Subject: ACCELERATOR PEDAL HINGE BROKEN AT BASE	Bulletin No: 01-013/16
	Last Issued: 05/19/2016

DESCRIPTION

Vehicles Without Kick Down Switch (GHP9-41-600F)

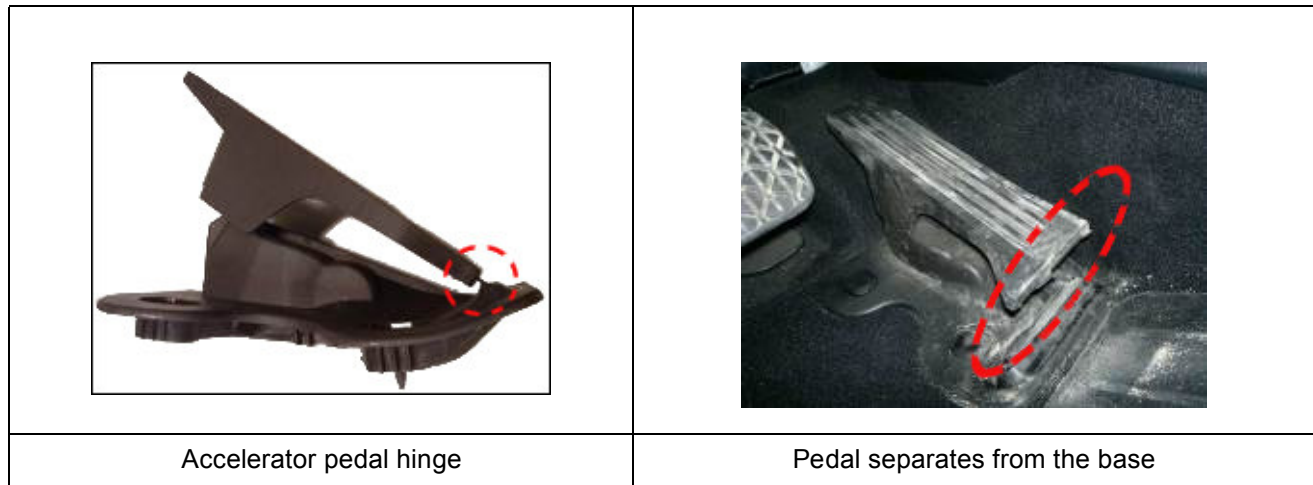
Some vehicles may exhibit the accelerator pedal hinge separating from the base in cold temperatures below 32 degrees Fahrenheit (0 degrees Celsius).

The accelerator pedal has been changed to increase durability.

Customers having this concern should have their vehicle repaired using the following repair procedure.

1. Verify customer concern.
2. Replace the accelerator pedal. Refer to MS3 online Workshop Manual section 01-13:
 - CX-3 - ACCELERATOR PEDAL REMOVAL/INSTALLATION
 - CX-5 - ACCELERATOR PEDAL REMOVAL/INSTALLATION
 - Mazda2 - ACCELERATOR PEDAL REMOVAL/INSTALLATION
 - Mazda3 - ACCELERATOR PEDAL REMOVAL/INSTALLATION
 - Mazda6 - ACCELERATOR PEDAL REMOVAL/INSTALLATION
3. Verify repair.
